Submittal 209-001-012

ADDENDA
00 91 13 E-03

Project:
COMMUNITY CARE CITY OF KAWARTHA LAKES CCCKL COMMUNITY HEALTH CENTRE

Drawing Title:
GROUND FLOOR PLAN - POWER AND SYSTEMS

1.1 Refer to Drawing E300 – Ground Floor Plan – Power & Systems (issued within)

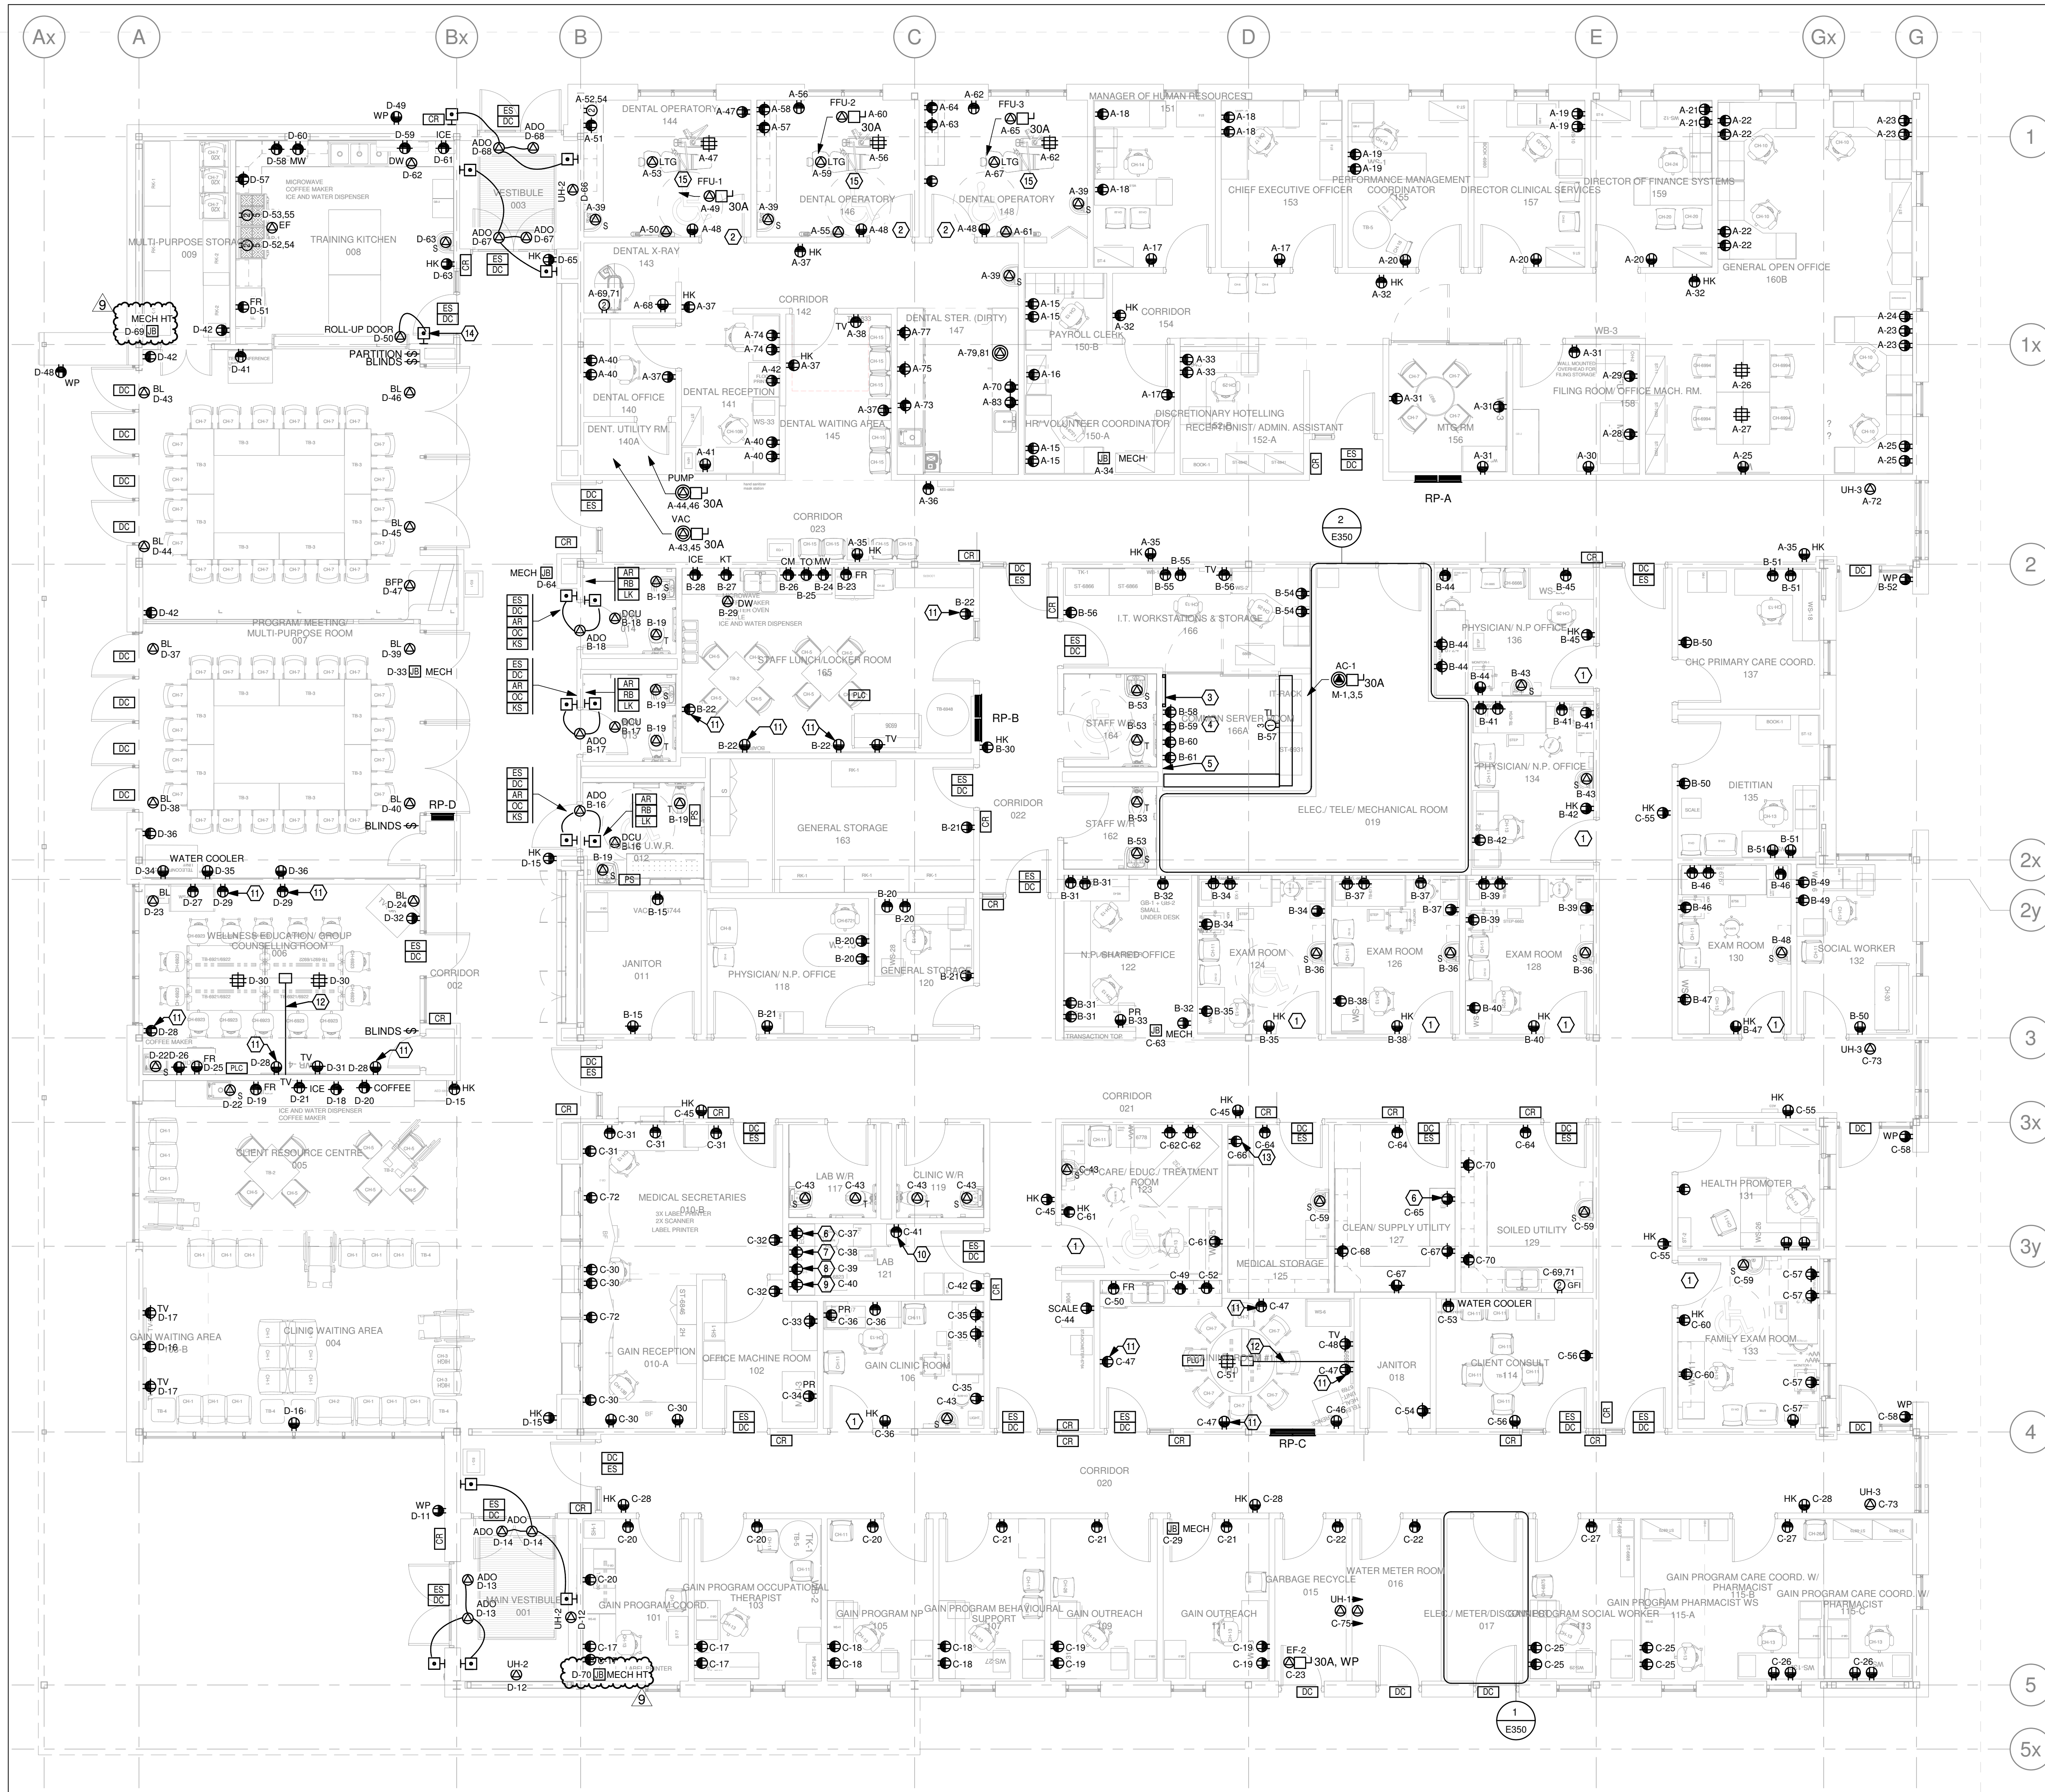
- .1 Added two 120V GFI circuits to be used for heat tracing. Power is by division 26, heat tracing cables, controller etc are by division 20.
